STAFF'S
REQUEST ANALYSIS
AND
RECOMMENDATION

00PR0149

Laverne C. Cole
(Cole C'Store)

REQUEST: Site Plan Approval.

SITE LAYOUT AND UTILITY PLAN

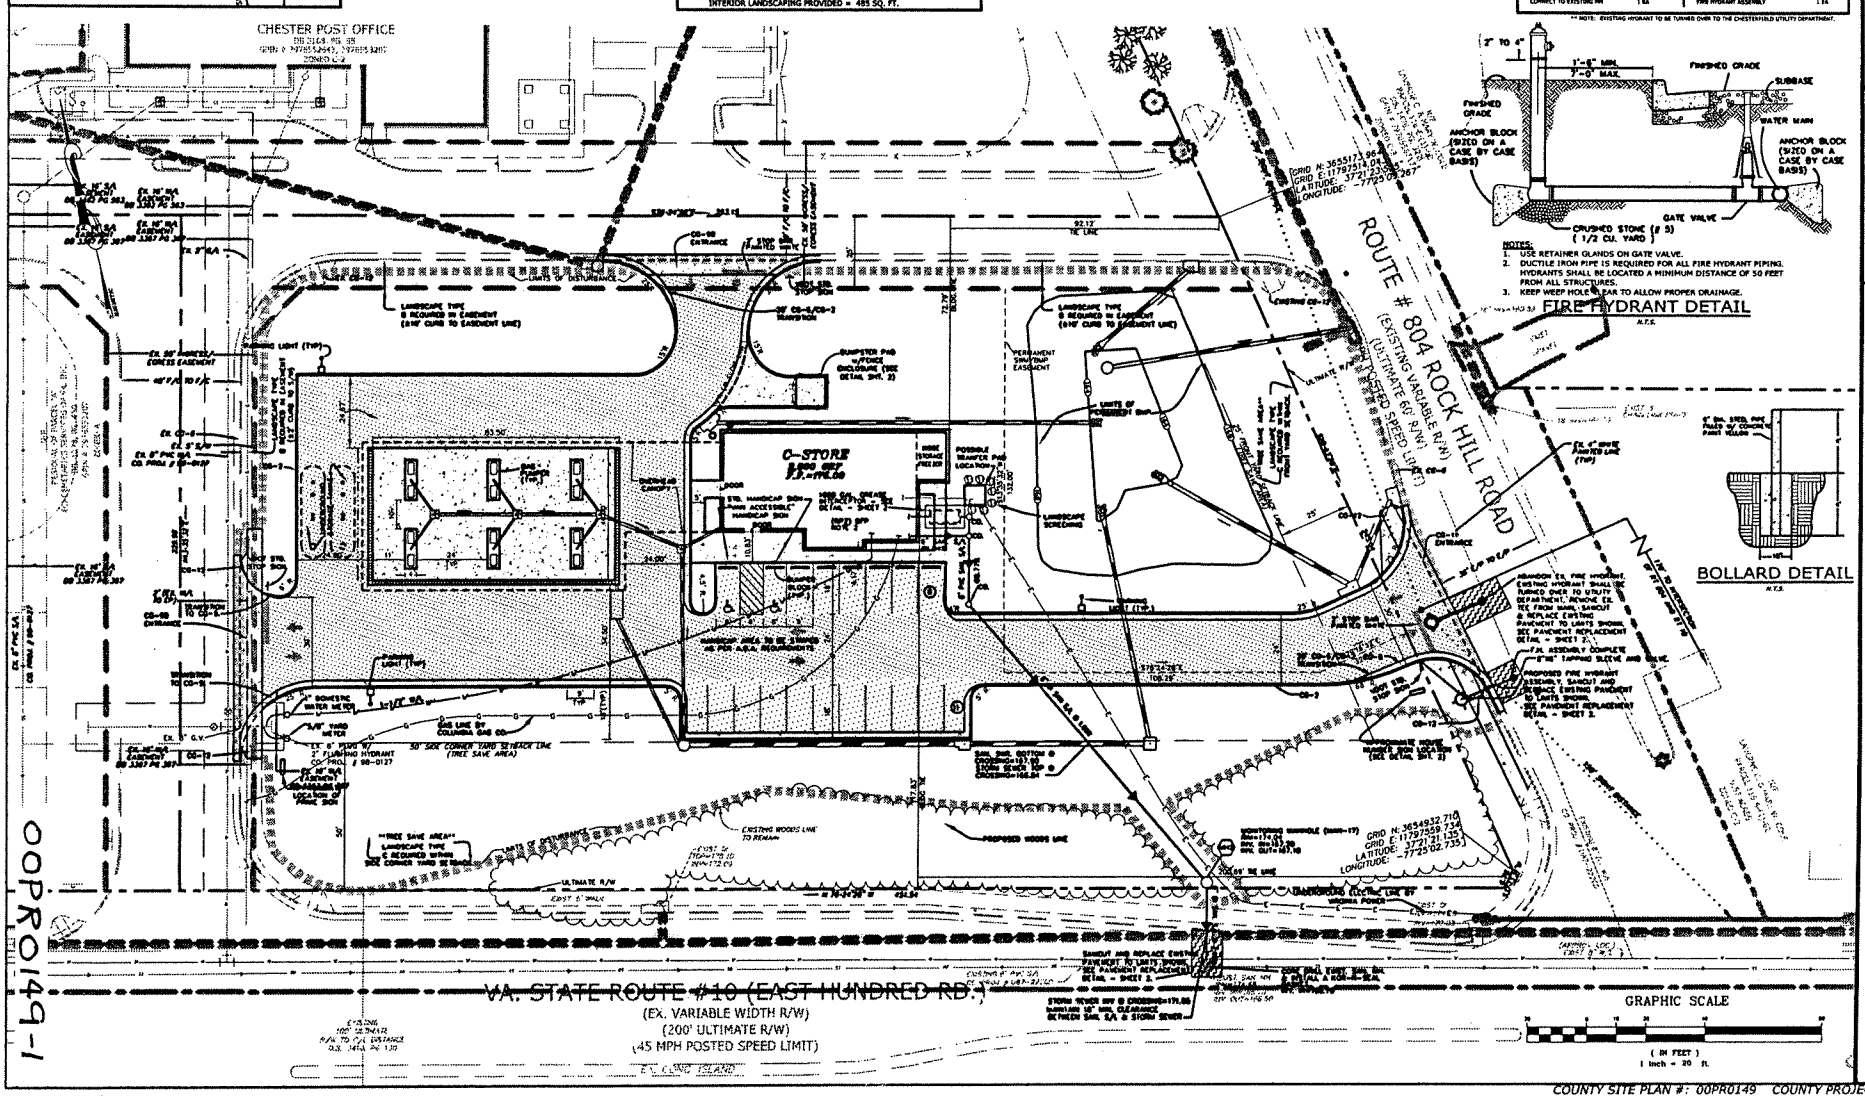
3. Show and label UD-4 along with CG-11 line across the site entrance. (T & VDOT)

4. The meter sizing form now shows flush valve toilets, which requires a 1.5" meter. If tank-type toilets are used, the 1" shown will be adequate. (U)

5. Show the existing manhole number as "V". (U)

6. Show the storm sewer on the sewer lateral profile near the existing manhole. (U)

7. It is recommended to show the sewer lateral as ductile iron pipe and to reduce the slope to 1.00% to pick up more cover. (U)

12. Per previous comment 4, revise the grading and storm water sewer as needed to retain all trees within the front yard setback and the corner side yard setback. This may require a retaining wall and a relocation of parking to allow this wall to be located outside of the setback. (P)

13. Per previous comment 6, relocate the sanitary sewer out of the tree save area. For this site you may locate the sanitary sewer 30 feet or more from existing trees. (P)

14. Per previous comment 10, relocate the electric service line outside of the tree save area. For this site you may locate the electric service 30 feet or more from existing trees. (P)

FRONT ELEVATION

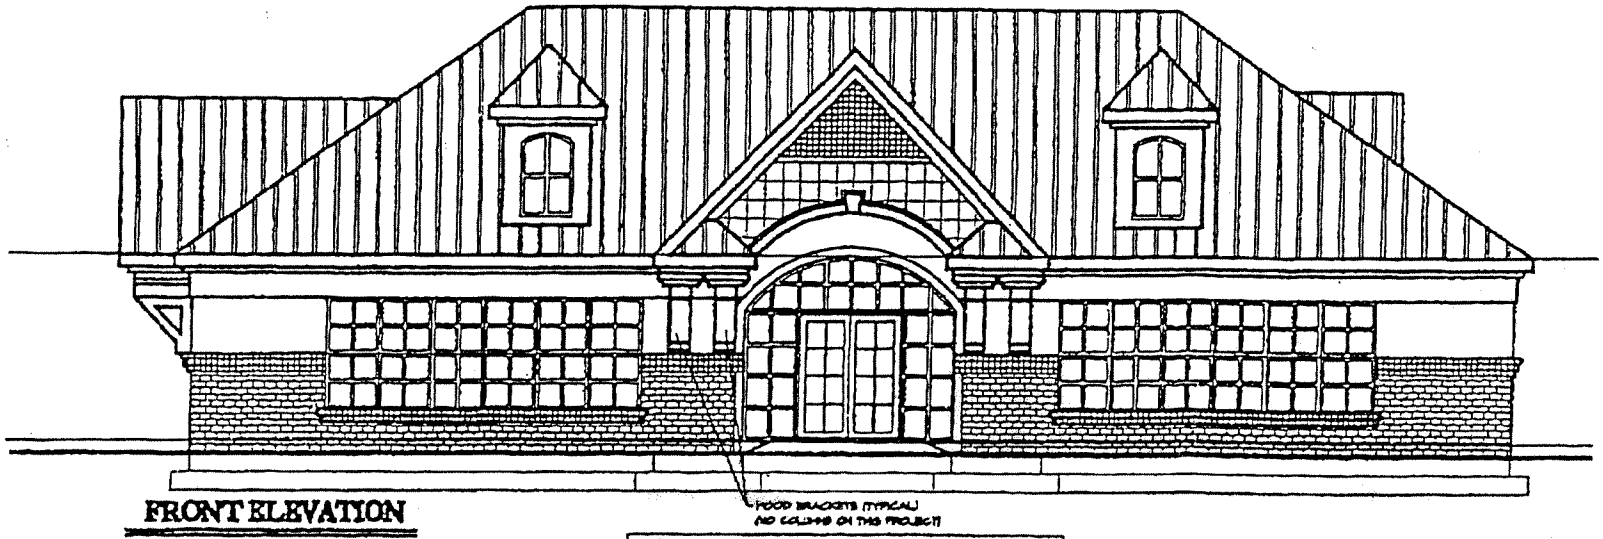
15. Architectural elevations of the store and gas canopy must be submitted that reflect the site plan layout and that is compatible with the Chester Police Station. (P)
